PLANNING APPLICATION PLN-18-0224

40 BURGHLEY STREET, LONGFORD

ATTACHMENTS

Site - Planning Compliance

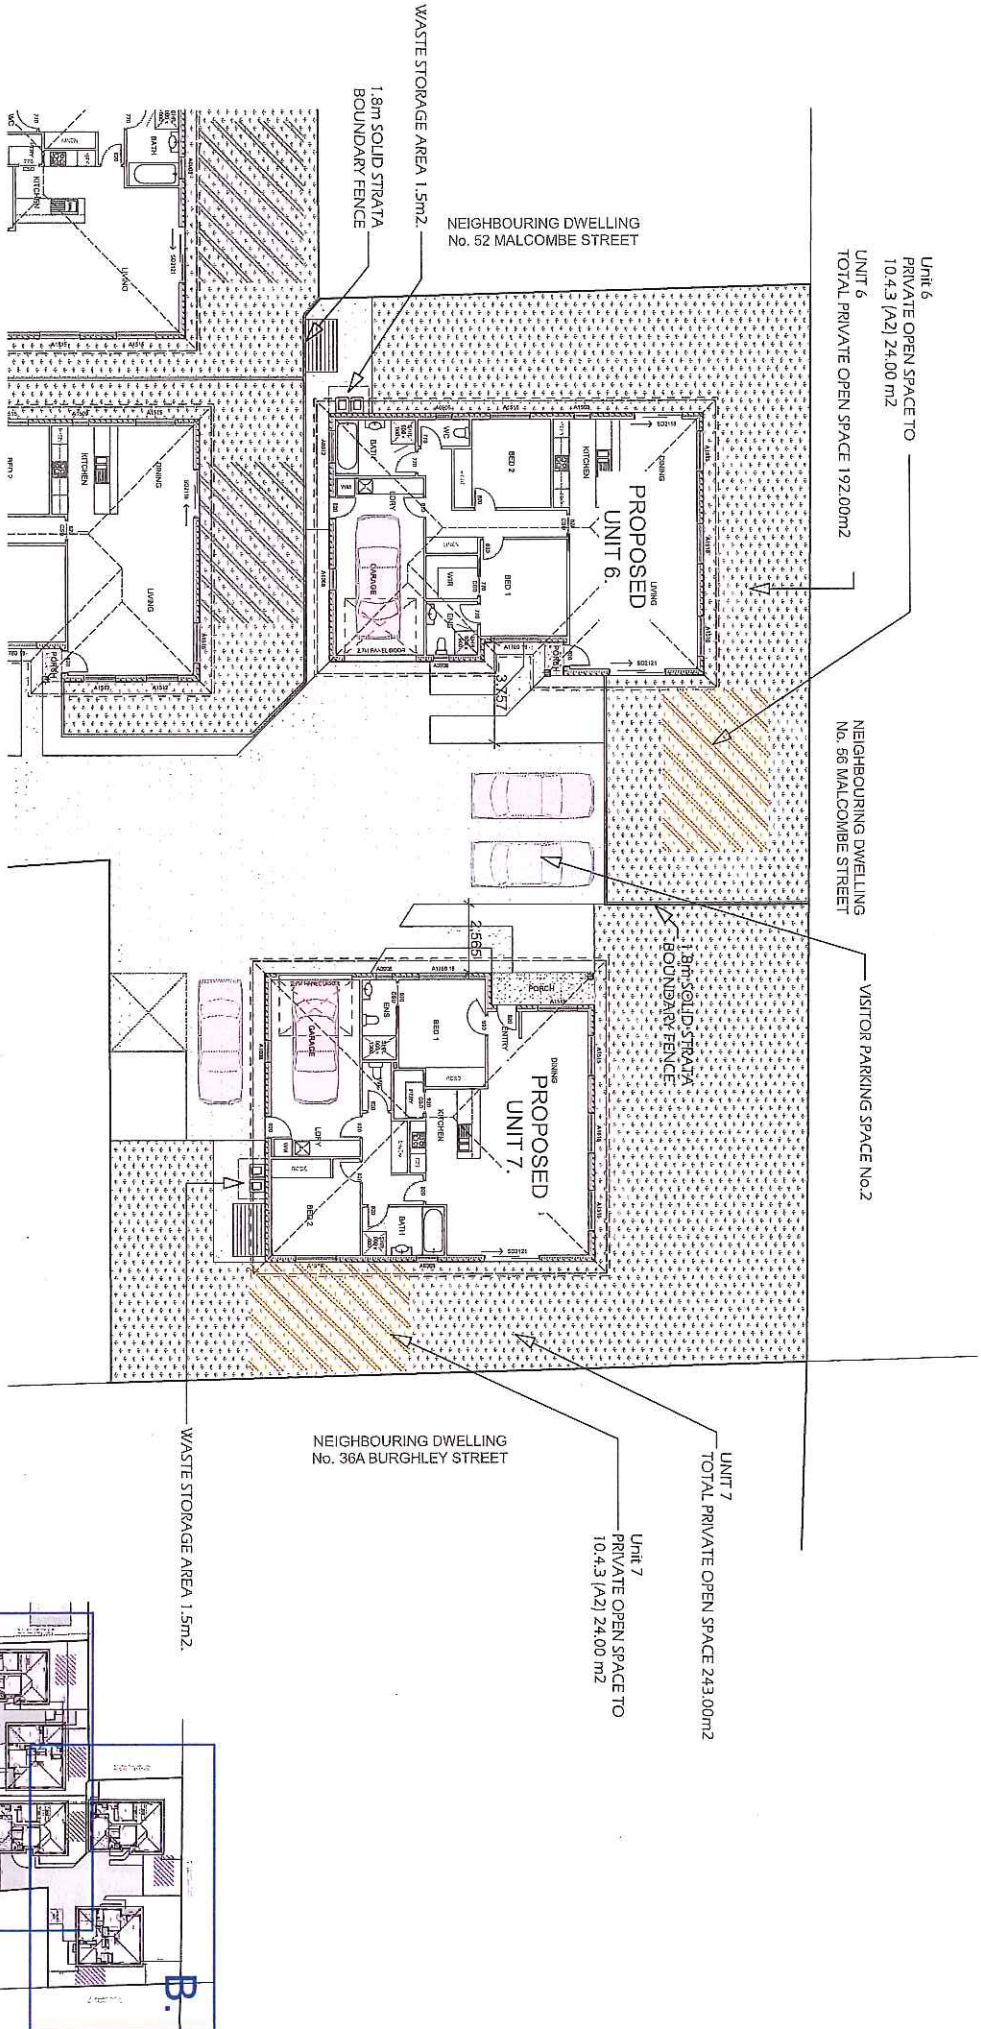
- Unit 6, according to the house measurements on the plans does not fit in the proposed area with the 4m gap from my boundary. I found this after an on site visit. All measurements are to the house brick work and do not include the eaves and spouting which would add another 1050m to each dwelling, do the remaining buildings have the same issue in their allotted space?

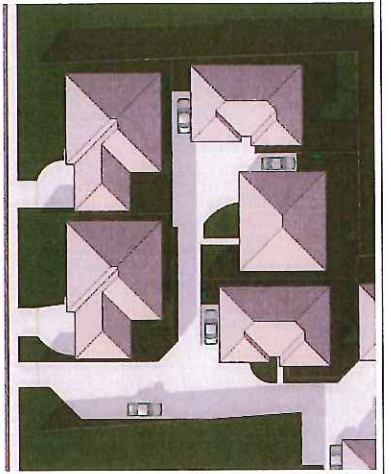
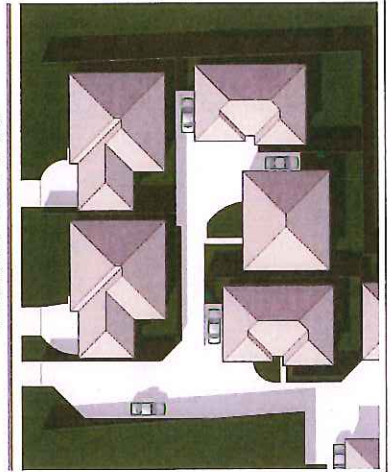
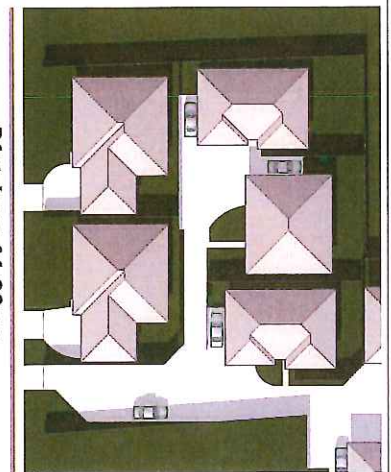
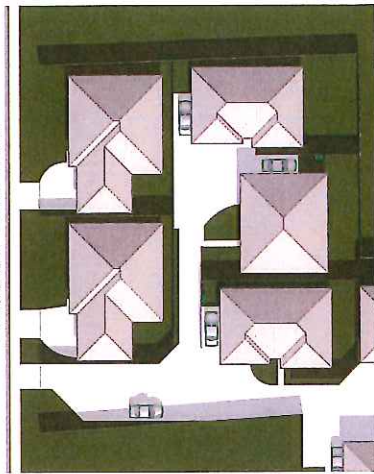
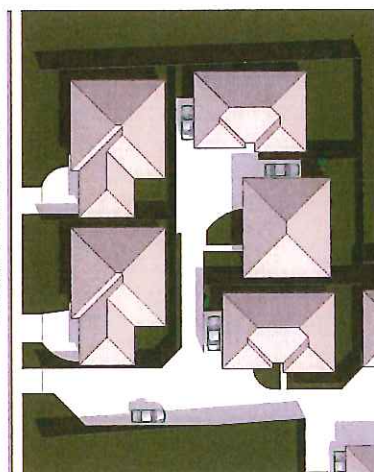
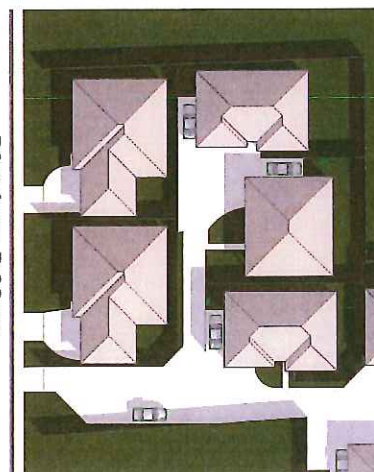
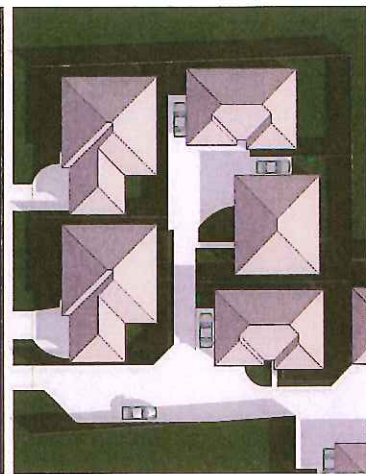
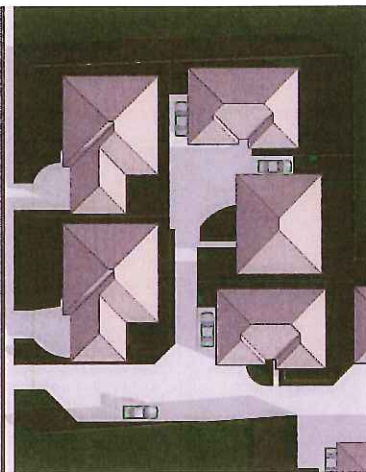
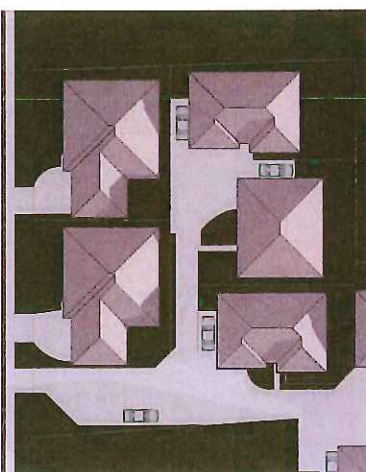
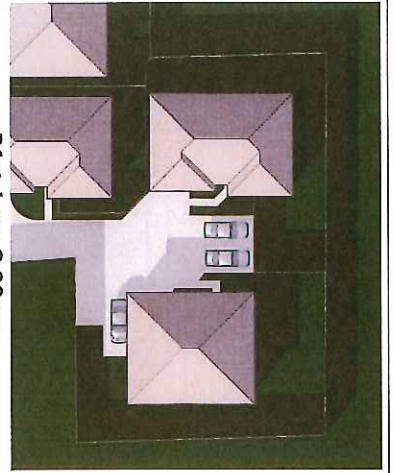
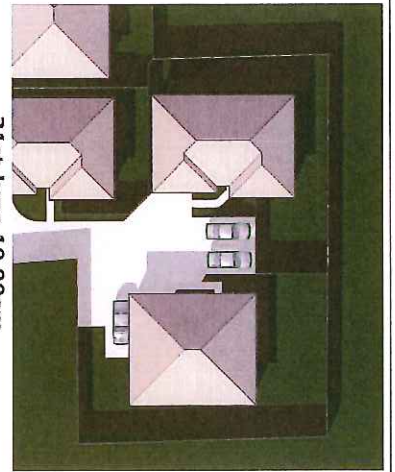
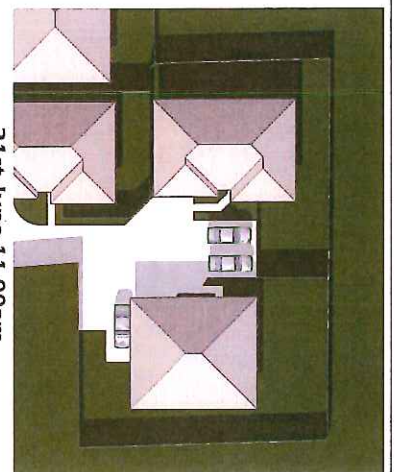
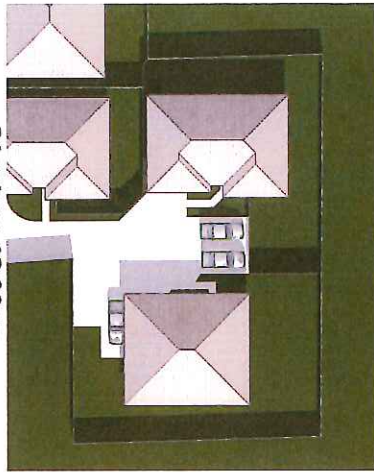
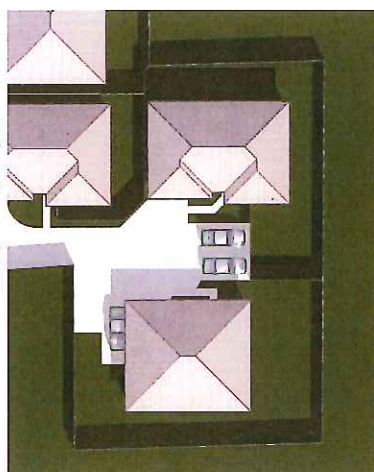
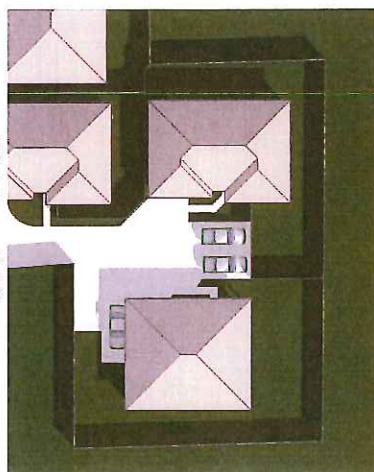
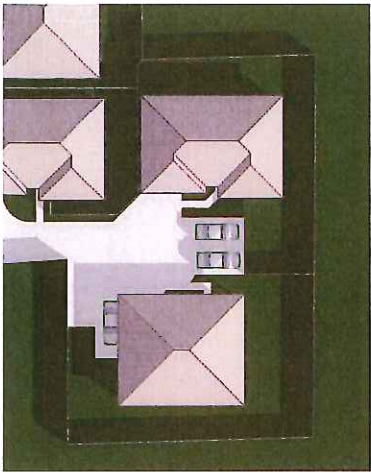
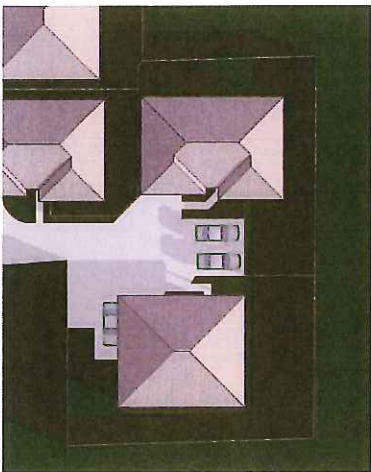
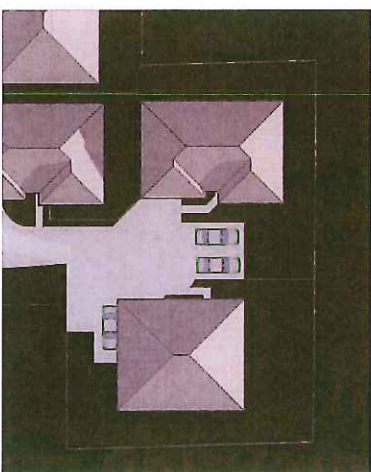
No. 3 Unit on the plan adjoins our property at 50 Malcombe St. Longford. I note No. 1 Unit is 2m from the boundary. No. 3 is 1500mm from our boundary and observe the shadowing on the plan which is taken from an elevation of 2400mm but slab foundation could be 300-500mm above existing ground level. This would make a significant difference to the shading. If this boundary distance could be increased to 2m or even 1.8 it would make a big difference to the projected shadowing.
